*BEACON PLANNING BOARD
One Municipal Plaza - Courtroom
BEACON, NEW YORK 12508
Phone (845) 838-5002 Fax (845) 838-5026*

The Planning Board will meet on **Tuesday, January 8, 2019** in the Municipal Center Courtroom. A work session will take place at 7:00 PM for a training workshop, discussion of agenda items and/or topics of interest to the Planning Board. The regular meeting will begin immediately thereafter, but not later than 7:30 p.m.

Re: Site Plan
511 Fishkill Avenue (NYS Route 52)
Tax parcel: 6055-04-580285 (±10.33 acres)
City of Beacon, NY

Re: 511 Fishkill Avenue Street, Beacon, New York
Site Plan Application – Responses to Comments

Amendment to Site Plan Application
Existing Conditions Survey - Sheet 2 of 13

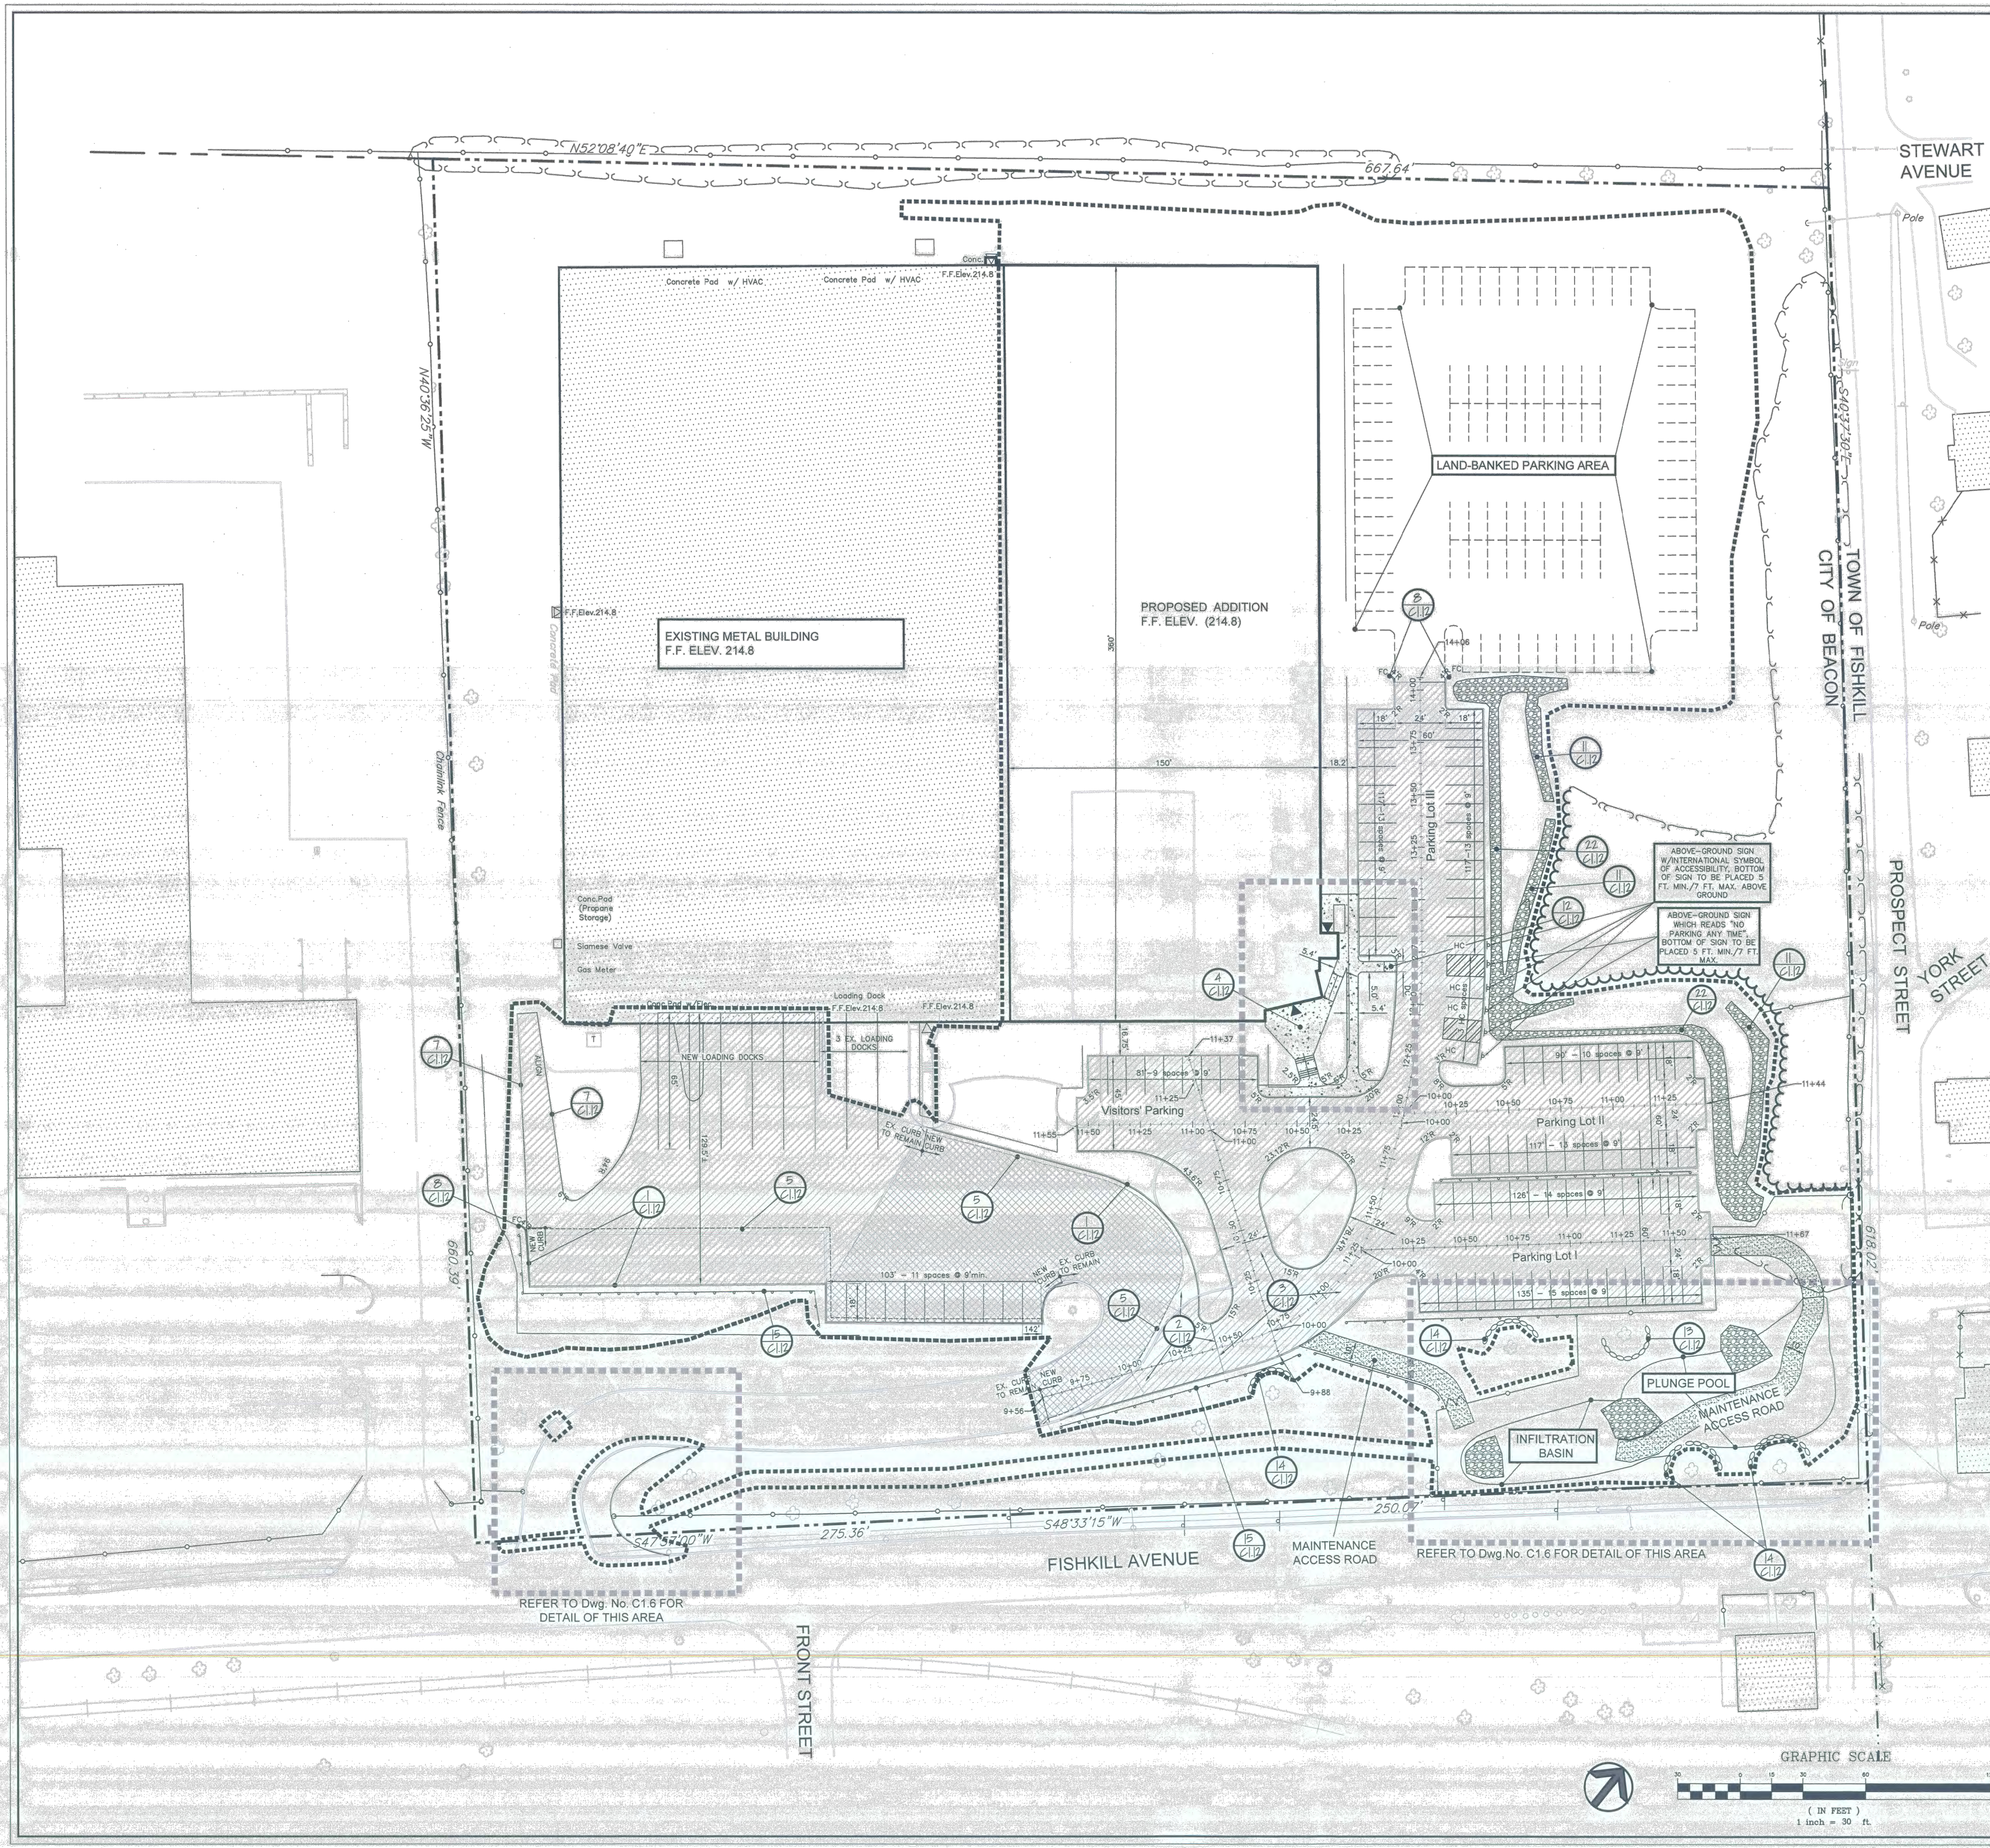
1. Comment acknowledged. The existing chain link fence along Fishkill Avenue is shown to be removed on the survey / existing conditions plan on Sheet 2.
2. Comment acknowledged.
3. Comment acknowledged. The EAF has been revised.
4. The parking spaces are 18' long, with generally 24' aisles, except as required to maintain the number of parking spaces proposed along the perimeter of the lot. So in some cases the aisles exceed 24' in order to maintain the parking count.
5. Trees have been added in the new parking lot.
6. A sidewalk connection from the new parking lot to the building entrance has been added.
7. The turning radius for trucks will be confirmed.
8. ADA parking will remain where it is because of grading issues near the building. A crosswalk has been added to the site plan.

NOTE: REMOVE EXISTING CHAIN LINK FENCE FROM FRONT OF PROPERTY (TYPICAL ALONG ROUTE 52 FISHKILL AVENUE FRONTAGE)

JOB #: 2016641
DATE: 11/27/18
SCALE: 1" = 20'
TITLE: GD-1
SHEET: 9 OF 13
UNAUTHORIZED ALTERATIONS OR ADDITIONS TO THIS DRAWING IS A VIOLATION OF SECTION 7209.2 OF THE NEW YORK EDUCATION LAW

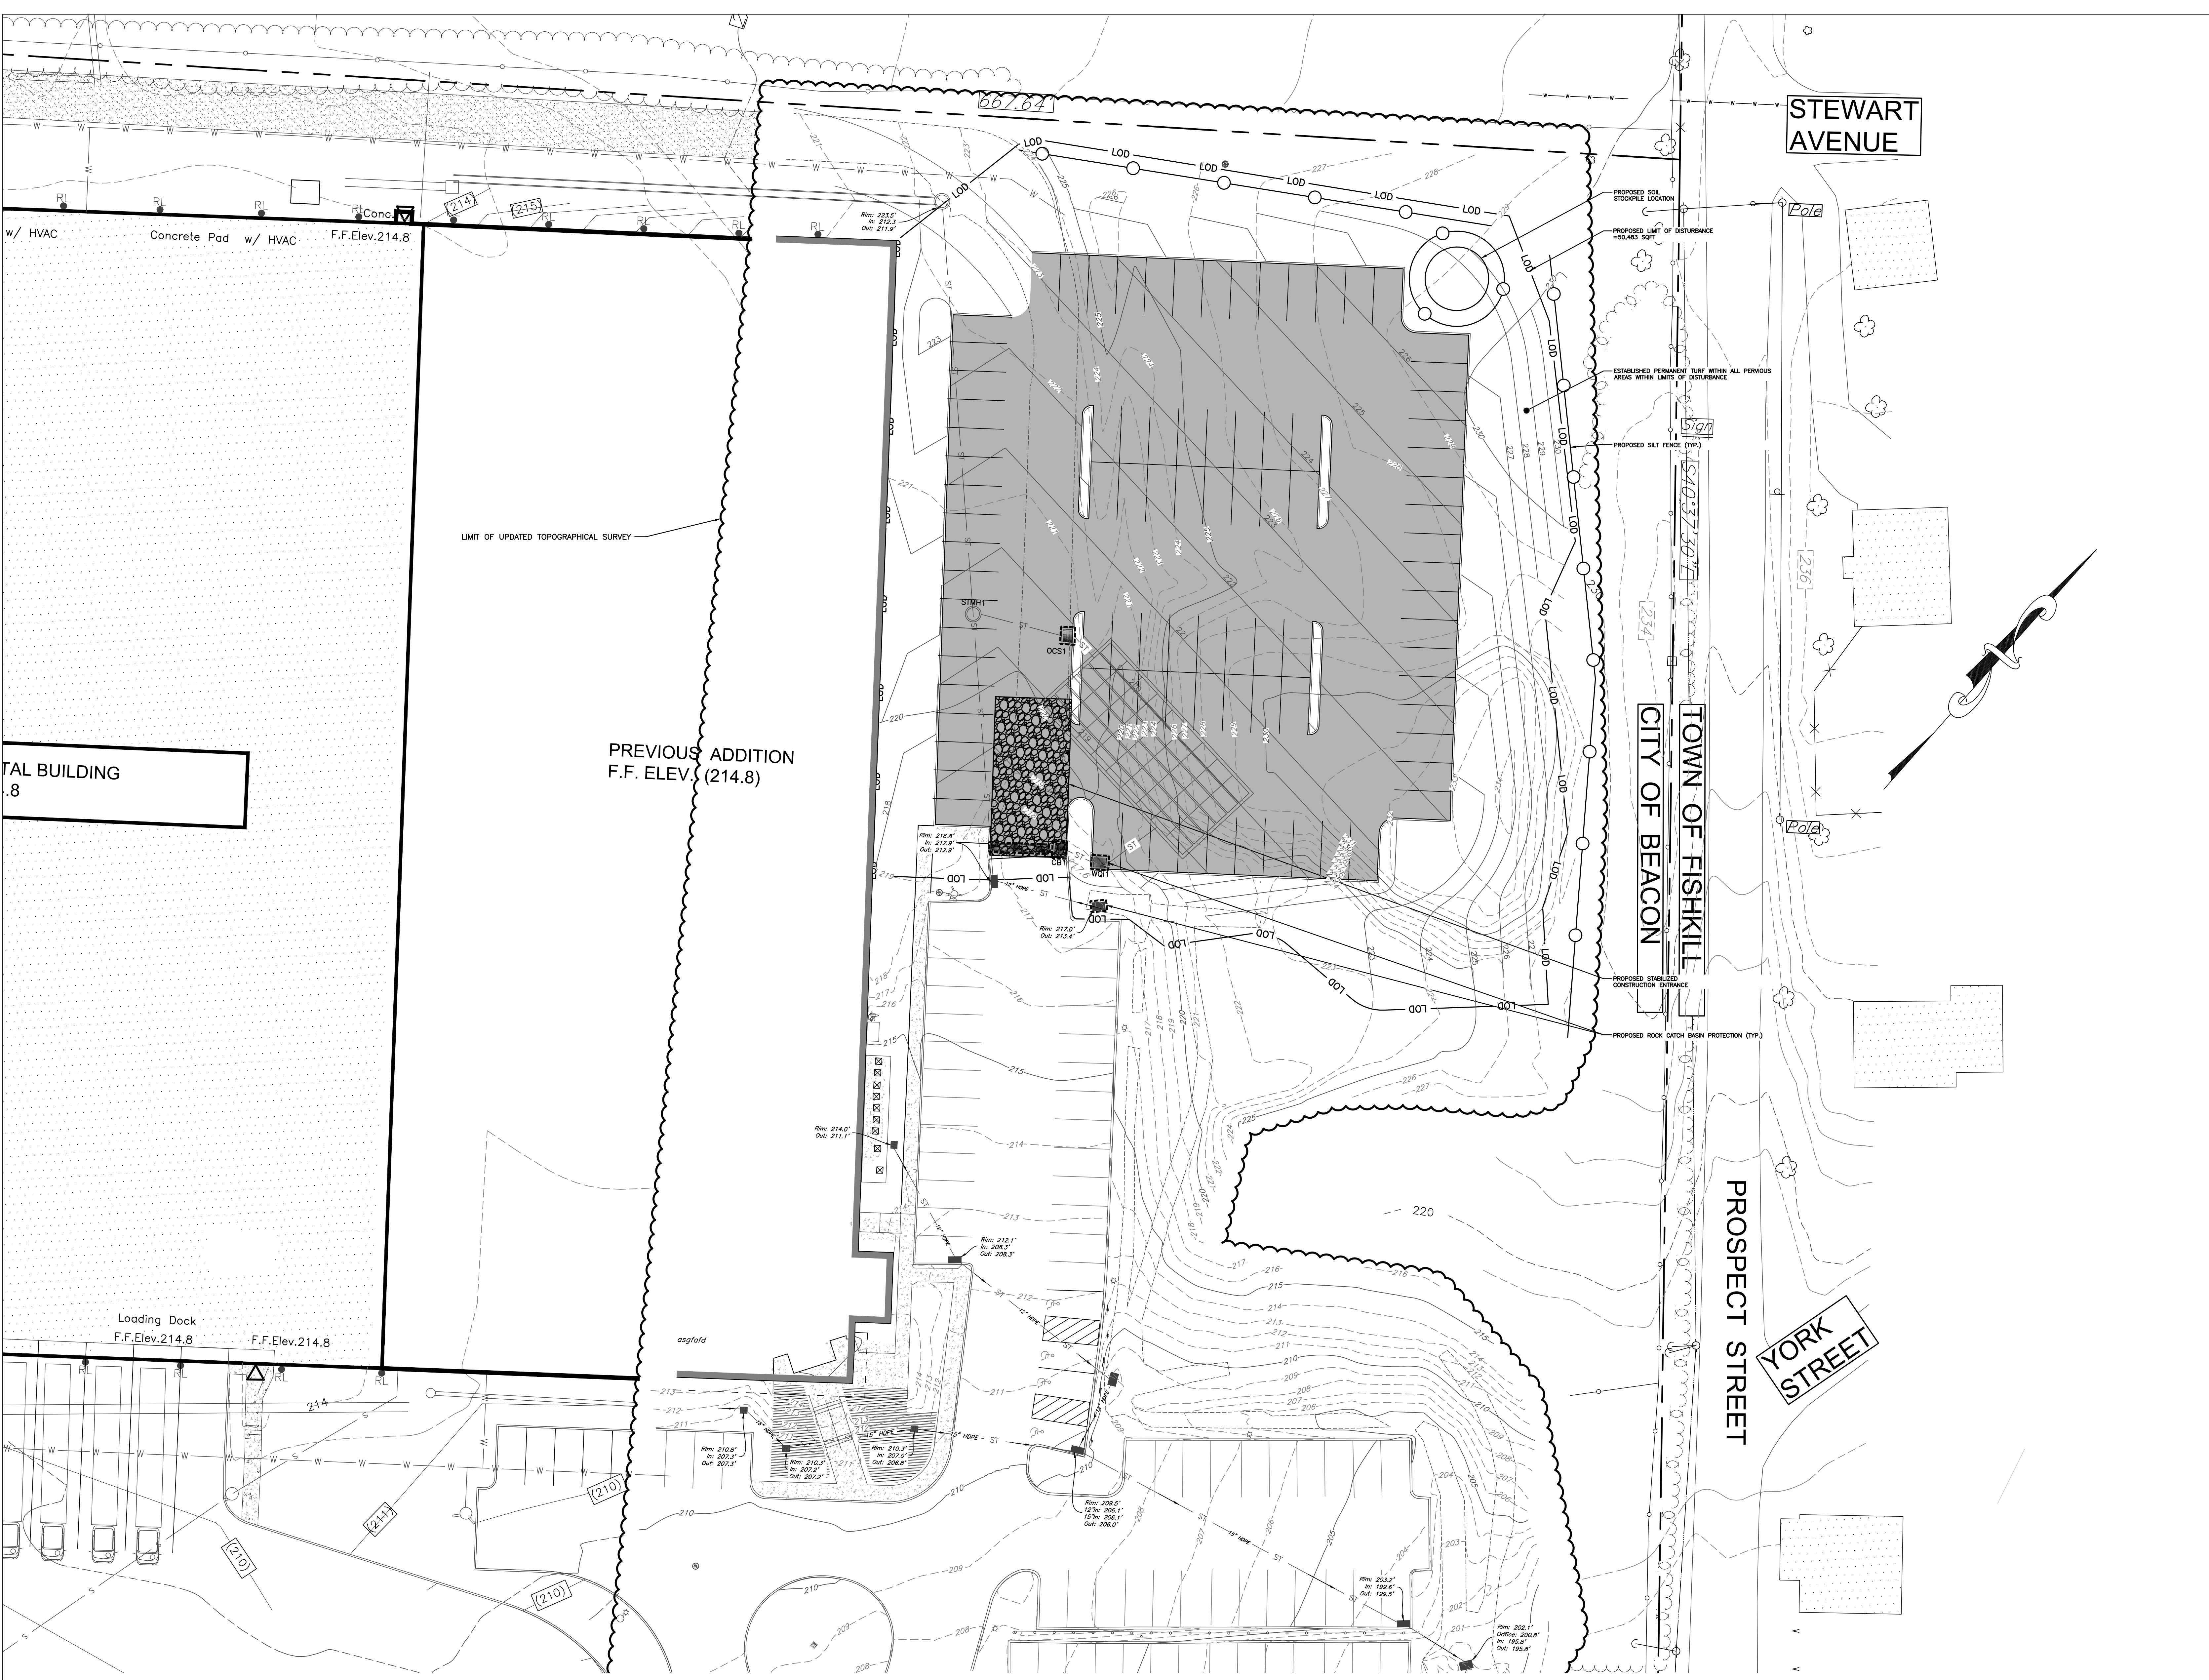
Sheet 9 of 13:

1. A north arrow has been provided on the sheet.
